## ADDENDUM NO. TWO

**March 22, 2019**

Project: View 1, 2 Wards – Mechanical Upgrade  
R&I Building Remodel  
Oakley ID Stake  
503-8669

SKETCH ADD. #1-1

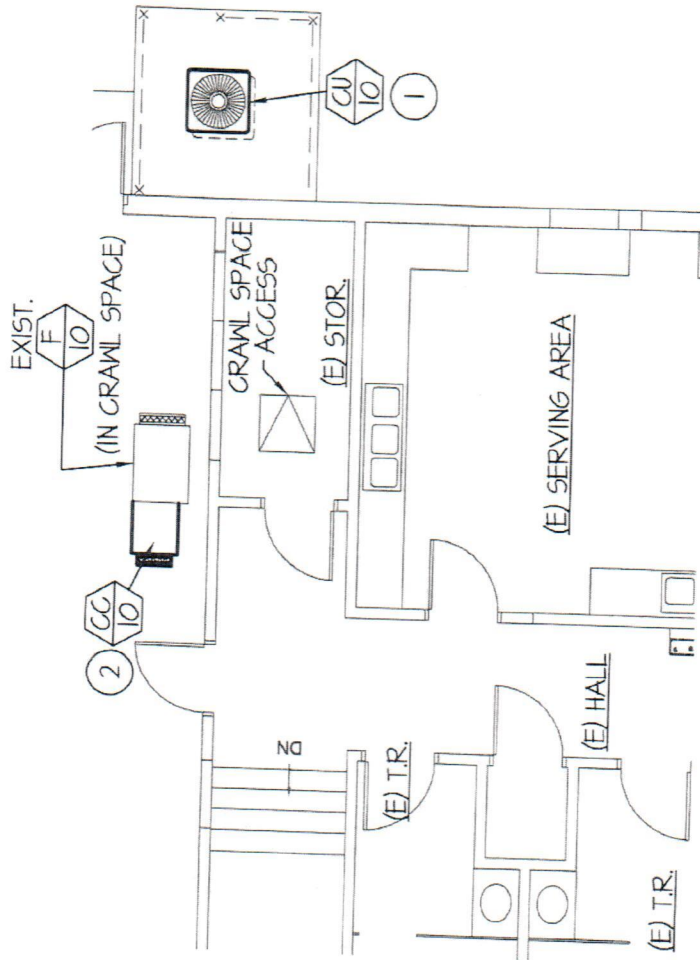
Item VI-1. Sheet MPE-2  
Sheet MPE-1 Shift location of new CU-8 and CU-9 to the East as per Sketch 1-1.  
Add to the base bid, replace existing CU-10 and CC-10 with new as per sketch 1-2 and 1-3.

# MECHANICAL REVISION 3-20-19

- ⑧ INSTALL NEW REFRIGERANT PIPING FROM EXISTING COOLING COIL ON FURNACE AND RUN ACROSS CEILING TO CORNER OF MECH. ROOM. DROP PIPING DOWN EXPOSED ON WALL TO FLOOR AND THRU EXTERIOR WALL TO CONDENSING UNITS AS SHOWN. SEAL HOLES IN WALL WEATHERTIGHT.
